**Committee of Experts on the Transport of Dangerous Goods  
and on the Globally Harmonized System of Classification  
and Labelling of Chemicals**

**Sub-Committee of Experts on the Globally Harmonized System  
of Classification and Labelling of Chemicals**

**Outcome of the Working Group on Explosives of the TDG  
Sub-Committee**

## **Report of the Working Group on Explosives**

**Figure 10.4: PROCEDURE FOR AMMONIUM NITRATE EMULSION, SUSPENSION OR GEL, INTERMEDIATE FOR BLASTING EXPLOSIVES**

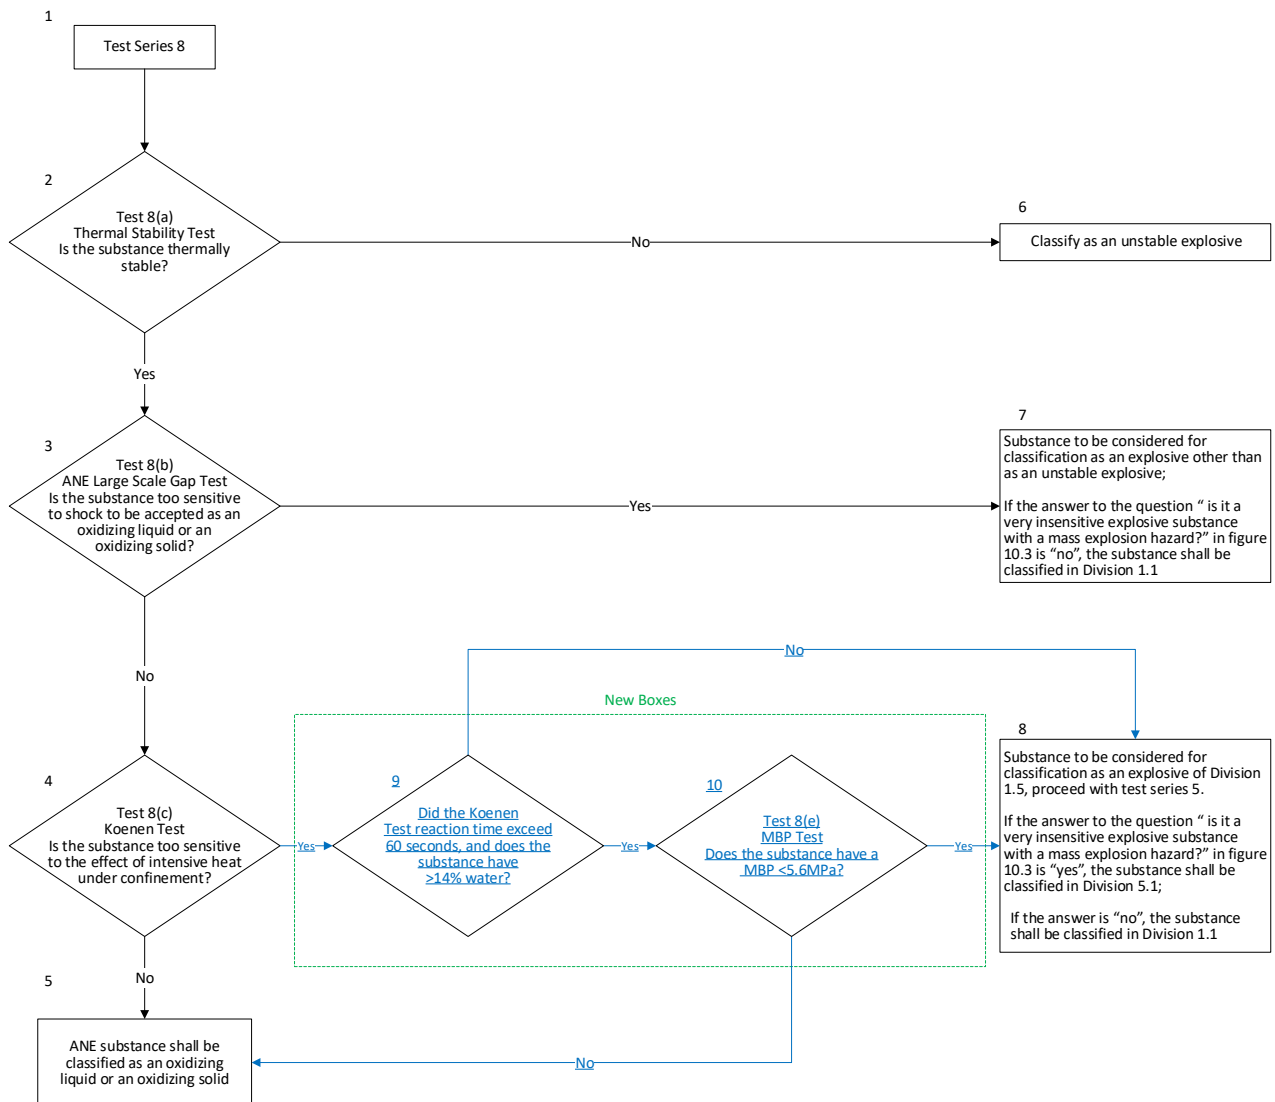
**Conclusion:** Although a consensus was not reached, the working group has prepared amended proposals for consideration by the Sub-committee. See Annex 3, Amendments 1 – 5 and Annex 4, Amendment 1.

**Section 10.4** – Amend Figure 10.4 as shown below:

Source: ST/SG/AC.10/C.3/2018/67 – ST/SG/AC.10/C.4/2018/17, Para. 17(a) as amended by the EWG (Para. 5 of this report).

**Figure 18.8.16.2.1**  
**Test cell for Canmet/CERL MBP Test**

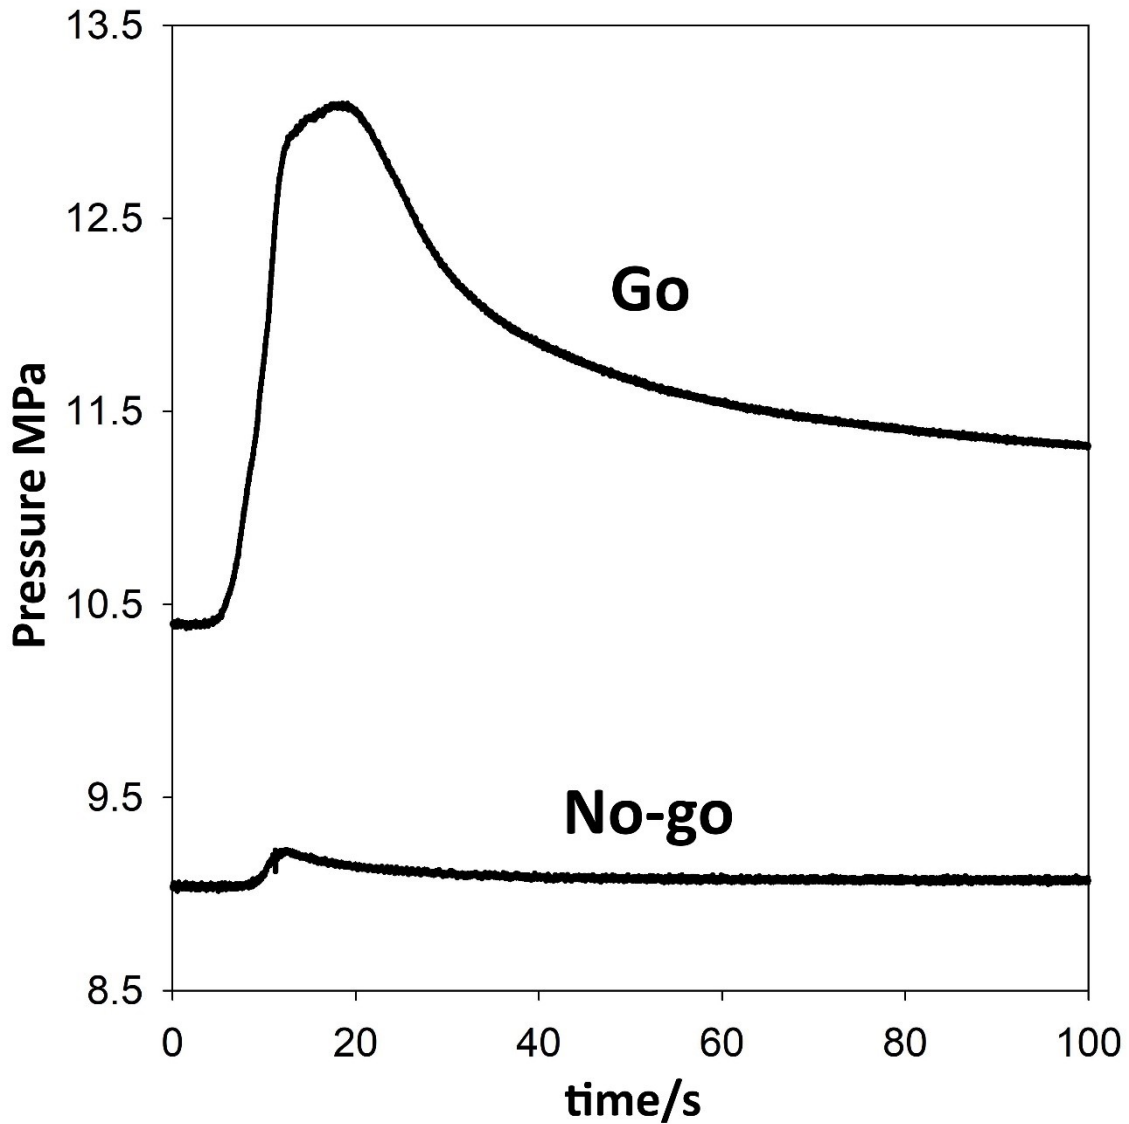
**Section 18.8** – Add new section 18.8 as shown below. In this amendment:

**18.8** ~~Test 8(e)(#):~~ [CanmetCERL minimum burning pressure \(MBP\) Test](#)

18.8.2.1 ~~6.2.2.1~~ The samples should be loaded in small cylindrical steel pipes (so-called test cells) having a nominal length of 7.6 cm and an internal diameter of at least 1.6 cm. Each test cell should have a 3-mm wide slit machined along the axis to allow combustion gases to escape during the tests (Figure 18.8.1 ~~6.2.1~~). The interior of each test cell should be painted with high-temperature non-conductive paint. Introduction of the sample into the cell should be done with caution to avoid causing crystallization of the sample and introducing air voids in the sample. Once the ignition wire has been introduced in the sample (see 18.8.2.2 ~~6.2.2.2~~), the ends of the cell are closed off with No. 0 neoprene, or similar, stoppers which must be reamed at their inside face to accommodate the splice connectors of the ignition wire assembly.

18.8.2.3 ~~6.2.2.3~~ The above test cell should be introduced in a pressure vessel so that the axis of the cell is held horizontal with the slit on top (Figure 18.8.2 ~~6.2.2~~). A minimum volume of ~~4/4~~ litres and an operating pressure resistance of 20.8 MPa (or 3000 psig) are recommended for this pressure vessel. The vessel must be equipped with two insulated rigid feedthrough electrodes capable of carrying an electric current up to 20 A and sealed so as to have a pressure rating equivalent to that of the vessel itself. ~~For safety reasons, it is recommended that the vessel be installed in a protected test room and should be equipped with a rupture disc assembly designed to vent the vessel at a pressure slightly lower than its maximum operating pressure.~~ The vessel should also be equipped with an inlet and an outlet. ~~In order to vent the vessel after a test, the outlet should be equipped with a high pressure valve that can be operated remotely.~~ The inlet should be used to pressurize the vessel to a predetermined initial pressure before the test. For convenience, it is recommended that the vessel also be equipped with a 0-25 MPa pressure transducer.

Source: ST/SG/AC.10/C.3/2018/67 – ST/SG/AC.10/C.4/2018/17, Para. 17(e) as amended by the EWG (Para. 5 of this report).

**Figure 2.1.4: Procedure for the classification of ammonium nitrate emulsion, suspension or gel (ANE)**

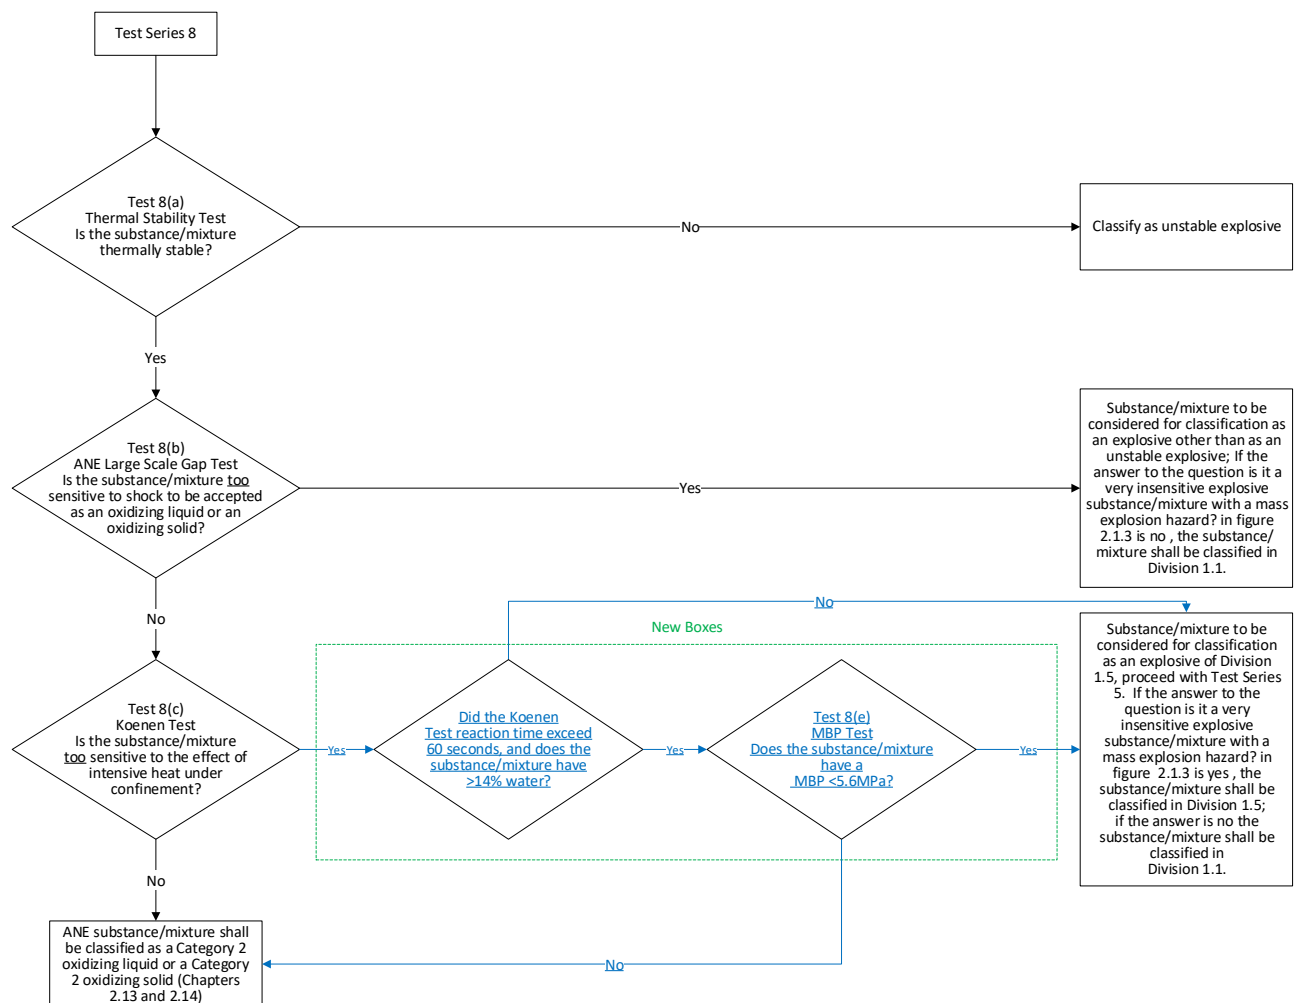
**Section 2.1.4** – Amend Figure 2.1.4 as shown

Source: ST/SG/AC.10/C.3/2018/67 – ST/SG/AC.10/C.4/2018/17, Para. 17(b) as amended by the EWG (Para. 5 of this report).
